Re: GLA 4558 - 9, 11 and 19 Osiers Road

This report has been produced to supplement the Flood Risk Assessment document reference 4618-FRA-jk-180726-jk-Rev2-RDCD, to provide additional information and clarification on items raised by the GLA during the Stage 1 consultation for the proposed development at 9, 11 and 19 Osiers Road, Wandsworth.

## 2. GLA Comments

Figure 3.1 Exceedance flow paths

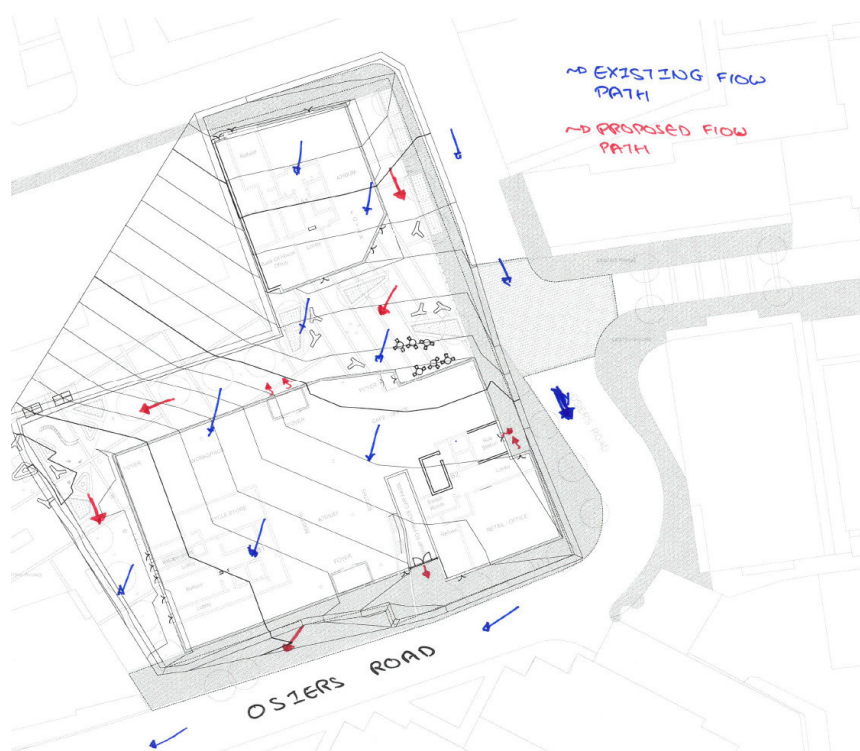
<p>14. No assessment of the exceedance flow paths has been provided. Additional information should be provided showing that exceedance flow paths, through the site are available in the case of attenuation system blockage or an extreme rainfall event.</p>	Section 3.7
<p>15. The surface water drainage strategy for the proposed development does not comply with London Plan policy 5.13 (a draft policy SI.13), as it does not give appropriate regard to the drainage hierarchy, Greenfield runoff rate and climate change. Further details on how SuDS measure at the top of the</p>	Section 3.3

An assessment of the exceedance flow paths based on the existing site levels demonstrates that the exceedance flows will be from the north eastern corner of the site to the southwestern towards the public highway. The topographical survey is included in Attachment B.

In the event of a system blockage or an extreme rainfall event the site levels and surface waters system should be designed to convey runoff away from the building and its users. The diagram below demonstrates the overland flow routes.

Due to the upper climate change limit being used for the drainage design exceedance flows are not expected to be significant. In addition most of the external landscaping will be permeable paving, so a flows generated by a blockage of the surface water system at a particular point in the system would likely drain back into the system at another point, without generating significant flows off site.

Client: **Hollybrook Limited**  
 Project: **Oslers Road**  
 Drawing: **Roof Floor Plan**  
 Scale: **1:200 (A1)** Date: **May 18** Status: **Planning**  
 Job Number: **5865** Drawing Number: **T20P14** Revision: **P4**  
 0018897\_SchemeT20P14

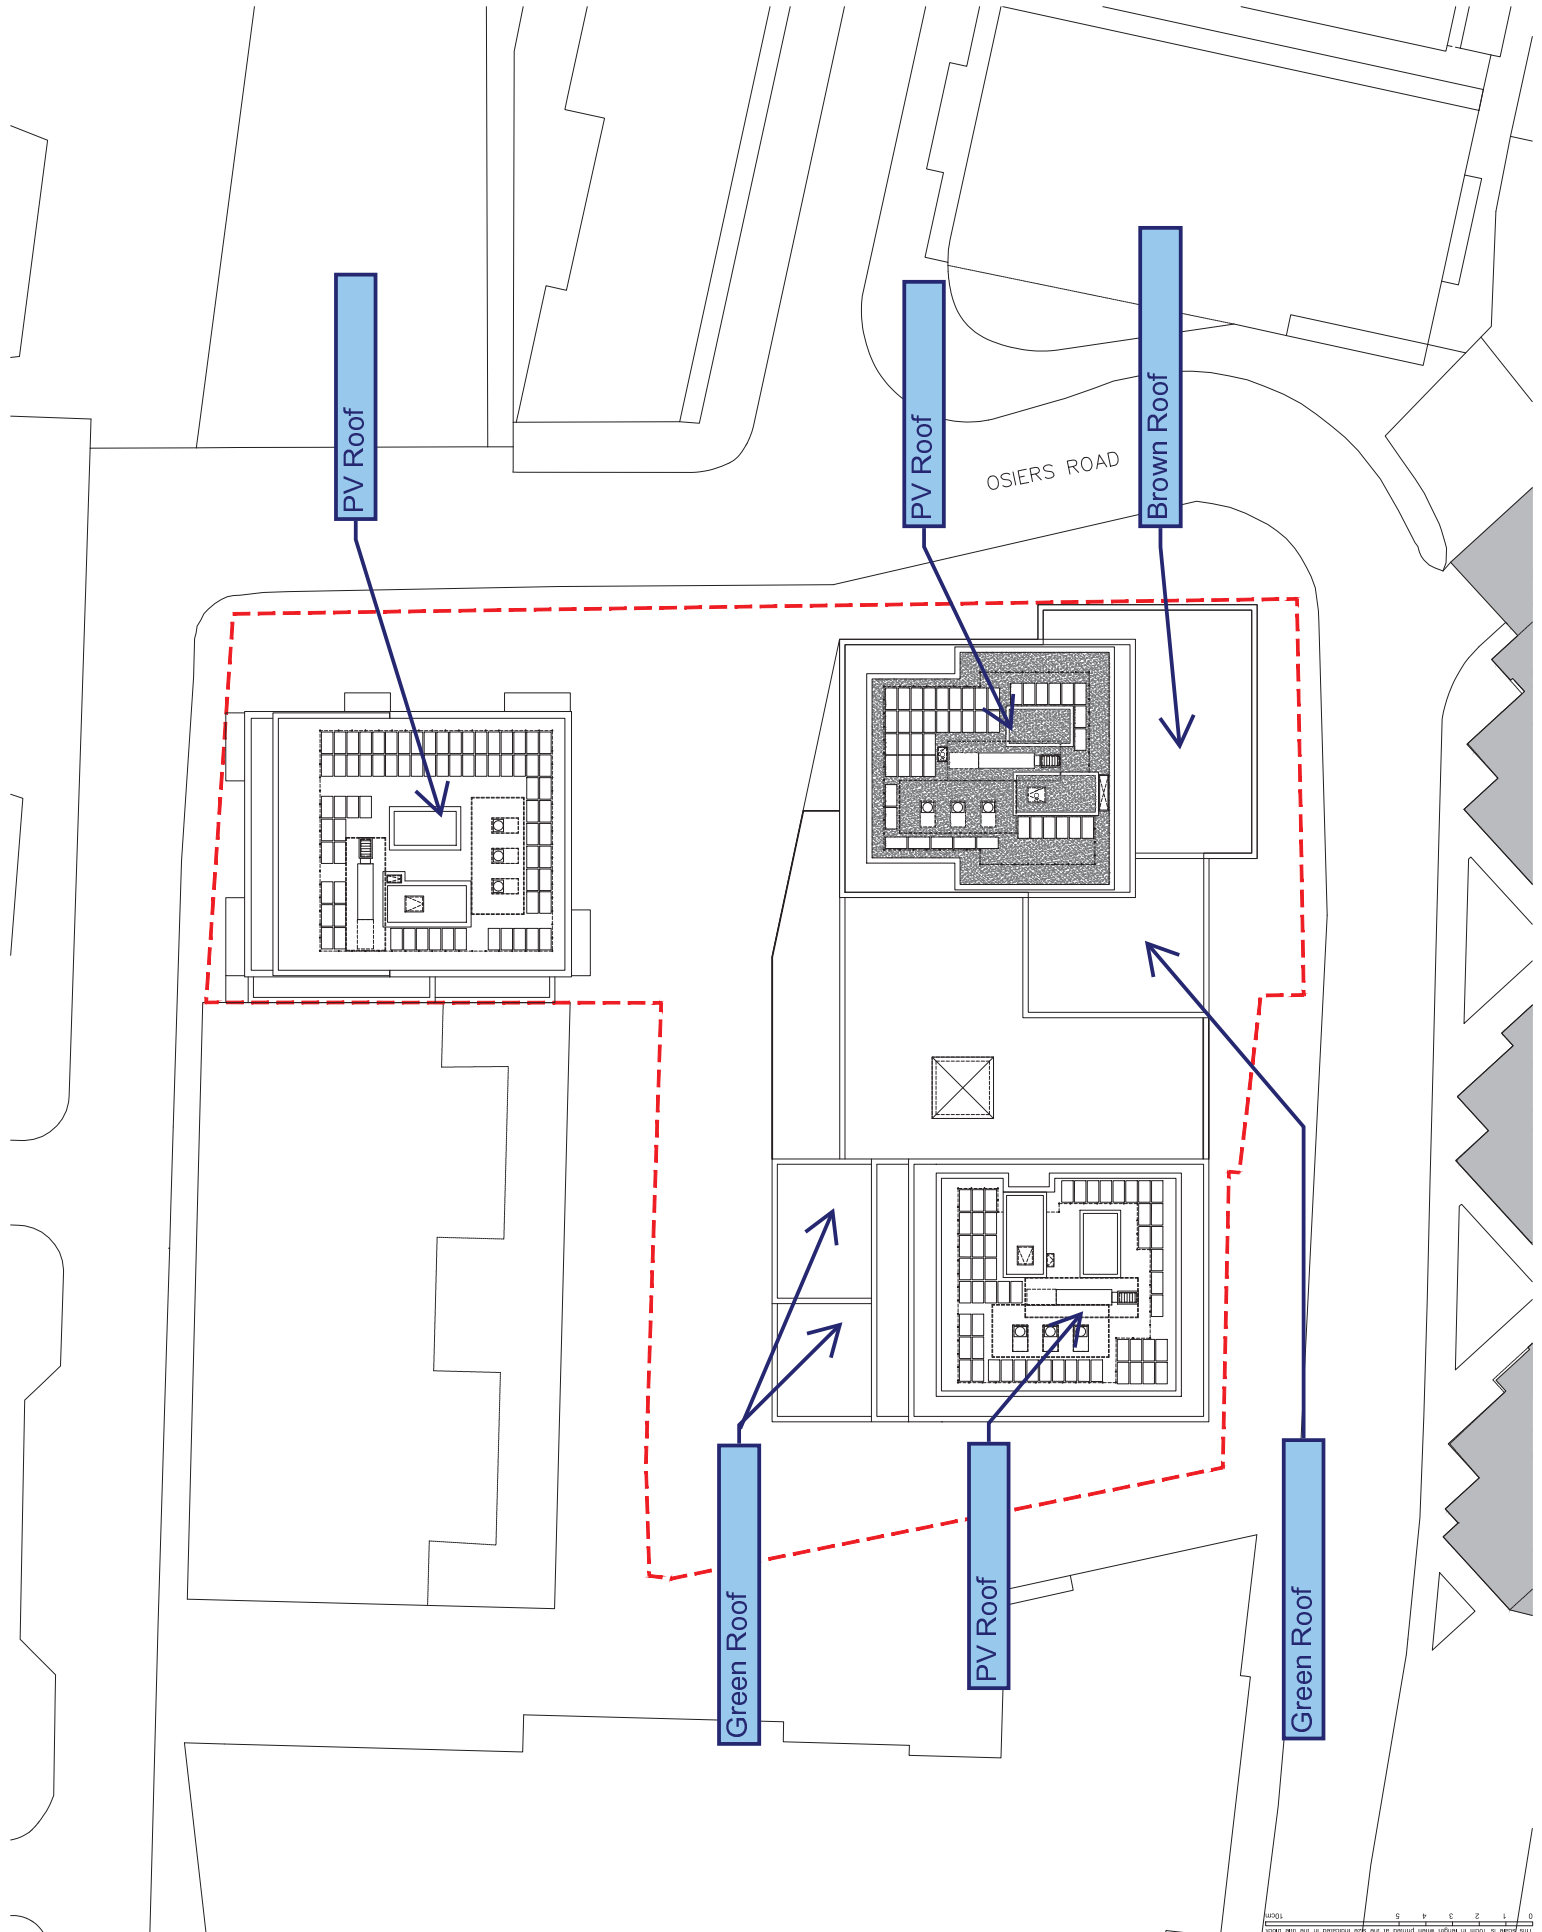
Information requested	Location Addressed
<i>2. The surface water drainage strategy for the proposed development does not comply with the London Plan policy 5.13 (and draft policy Sl.13), as it does not give appropriate regard to the drainage hierarchy, greenfield runoff rate and climate change. Further details on how SuDS measures at the top of the drainage hierarchy will be included in the development, and how greenfield runoff rate will be achieved should be provided. Additional attenuation storage volumes calculations, attenuation tank dimensions, and SuDS maintenance information should also be provided.</i>	Section 3.3

Green roofs are proposed at roof level as indicated on drawing T20P14 included in Attachment A. The drawing highlights roof areas that are to be used for photovoltaic modules and green roofs, roof areas that are to be used for photovoltaic modules are not considered viable for green roofs as well.

100% AEP  
Qbar discharge rate

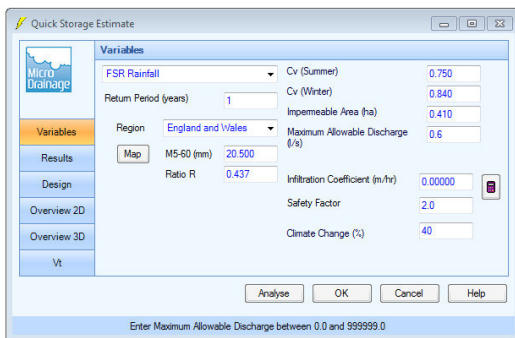
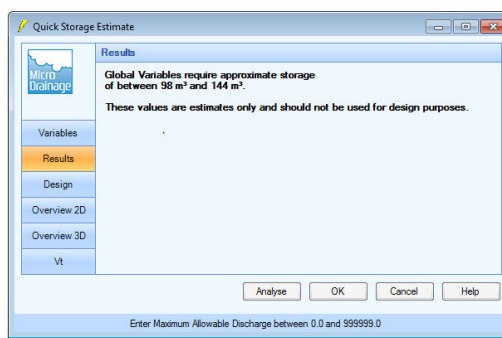
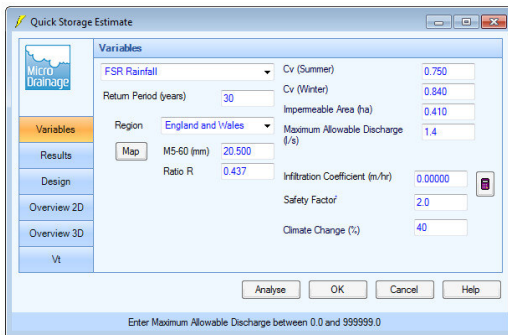
<p>3. The proposed development does not comply with the requirements of London Plan policy 5.15 (and draft New London Plan policy SI.15) as no water consumption target has been identified for the residential component of the development.</p>	Section 3.8
<p>9. The calculations of Greenfield runoff rates adopts an urbanisation factor of 0.75, representing partially developed catchment. The Greenfield runoff rate is intended to represent a partially developed catchment (literally a 'green field') and the use of an urbanisation factor greater than zero is incorrect. The applicant should provide revised Greenfield runoff calculations using an urbanisation factor of zero.</p>	Section 3.1
<p>10. The surface water drainage strategy addresses the Drainage Hierarchy, and notes that rainwater harvesting and green roofs would be possible options, and that infiltration is not feasible due to the site geology. Attenuation tanks are proposed as the main SuDS measure, and these are the only measures that are shown on plans. Permeable paving is mentioned but does not appear on landscaping plans. Opportunities for green infrastructure-based SuDS public realm areas have not been considered. This approach does not satisfy the requirements of London Plan policy 5.13 (and draft London Plan SI.13). The applicant should provide more detailed plans including rainwater harvesting, green/blue roofs, permeable paving and green infrastructure-based SuDS such as tree pits and raingardens.</p>	Section 3.4

Attachment D provides calculations on the discharge rates for  $Q_{bar}$ ,  $Q_{30}$  and  $Q_{100}$  and the resultant volumes of storage required for each return period. The critical return period, resulting in the largest volume of storage required, estimated to be  $336m^3$  is the 1% AEP with an additional 40% allowance for climate change. The table below summarises how the storage will be provided.

1% AEP  
Q100 Discharge rate

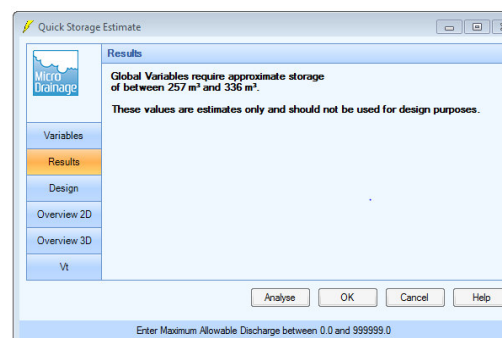
<p>11. The attenuation tank volume have been estimated using a simplified method, which gives an estimated attenuation requirement of 300m<sup>3</sup> for a design discharge rate of 2.3l/s in a 100 year event with 40% climate change allowance. Section 6.3 of the FRA suggests a range of potential design discharge rates, up to Q<sub>100</sub>. Where a design discharge rate greater than Q<sub>bar</sub> is proposed, more detailed calculations should be provided to show resultant discharge rates in a range of design events up to the 100 year event with 40% climate change allowance.</p>	Section 3.5
<p>12. Section 6.2.1 and 6.3 of the FRA show a 30% climate change allowance for design. This is not consistent with the value adopted in section 6.2.4 or current government climate change allowance guidance for small catchment areas.</p>	Section 3.2
<p>13. No maintenance plan has been included in the drainage strategy. The applicant should include a maintenance plan showing the maintenance and inspection frequency, and maintenance activities for each SuDS measure proposed.</p>	Section 3.6

Attenuation Feature	Storage Volume Provided
Below ground attenuation tank	$228m^3$
Permeable Paving subbase	$100m^3$
Blue Roof	$8m^3$

Section 6.2.4 of the FRA notes the required storage volumes based on 2.3l/s discharge rate for up to and including the 1% AEP with a 40% allowance for climate change. The updated calculations storage volumes noted in the table above are similar, albeit slightly higher, as they are based on a 2.0l/s discharge for the 1% AEP with a 40% allowance for climate change.
